## SERVICE ADVISORY

NO.: 20109 Rev D

**TO:** Owners and Operators  
**DATE:** October 28, 2022  
**SUBJECT:** Erroneous GPS position and momentary false TAWS alerts  
**REVISION D:** Added GPS 175/GNX™ 375/GNC® 355 and GTN Xi Resolution

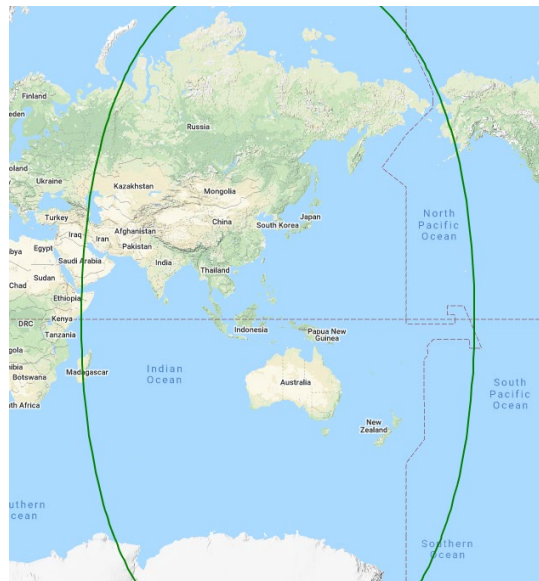
All SBAS-enabled Garmin Integrated Flight Decks (G900X, G950, G1000(H) G1000(H) NXi, Cirrus Perspective™, Embraer Prodigy™, G2000, G3000, G5000, and Embraer Prodigy® Touch systems), GTN Xi Series, GPS 175, GNX 375, GNC 355, GNS 400W/500W Series, GNS 480, GTN 6XX/7XX Series products operating within the area depicted below are affected.

Affected Garmin equipment may periodically experience GPS position errors for approximately six seconds, and momentary TAWS false alerts when utilizing corrections from the Japanese MSAS (MTSAT Satellite Augmentation System) space-based augmentation system.

Disable MSAS.

MSAS will be disabled automatically in the November 2020 aviation database cycle. A future software and database update will address the issue and re-enable the use of MSAS in the affected products.
